DESIGN REVIEW BOARD RECOMMENDATIONS

Date: October 4, 2023
Applicant: David Fowler
Site Address: 439 Eccles Ave
Project No.: P23-0076: CB23-0002, ND23-0004, DR23-0018 & TDM23-0005

Department Comments
P23-0076
439 Eccles Avenue

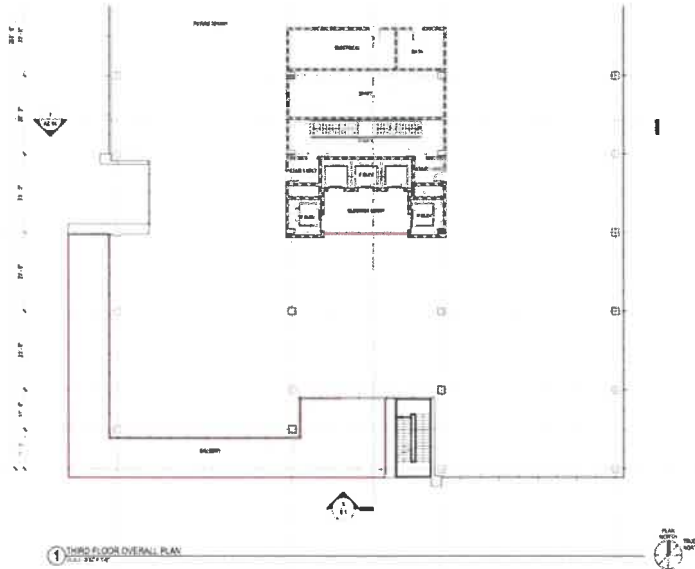
- A1. Sheet G-6: For the Proposed Office/Lab Building, the site plan shows the plan west fire separation distance is 27'-5" from the exterior wall to the property line. CBC Table 705.5 requires 2-hour rated exterior walls where the fire separation distance is less than 30 feet for an L occupancy building. Please address.
- A2. Sheet AE-21 shows a projection that is located in the fire separation distance. Check the maximum projection distance per CBC 705.2.

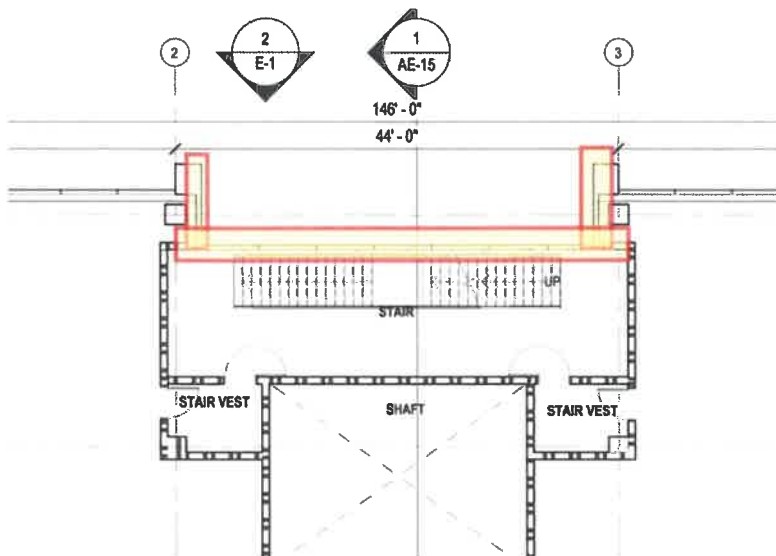
- A3. At the upper floors of the office building, please confirm and note on the plan the exterior stair will not be a required exterior exit stair as CBC 1027.2 does not allow the use of exterior exit stairs in a high rise or a building over 6 stories high.

A4. At the upper floors, review and address the highlighted sections of CBC 1023.7 noted below.
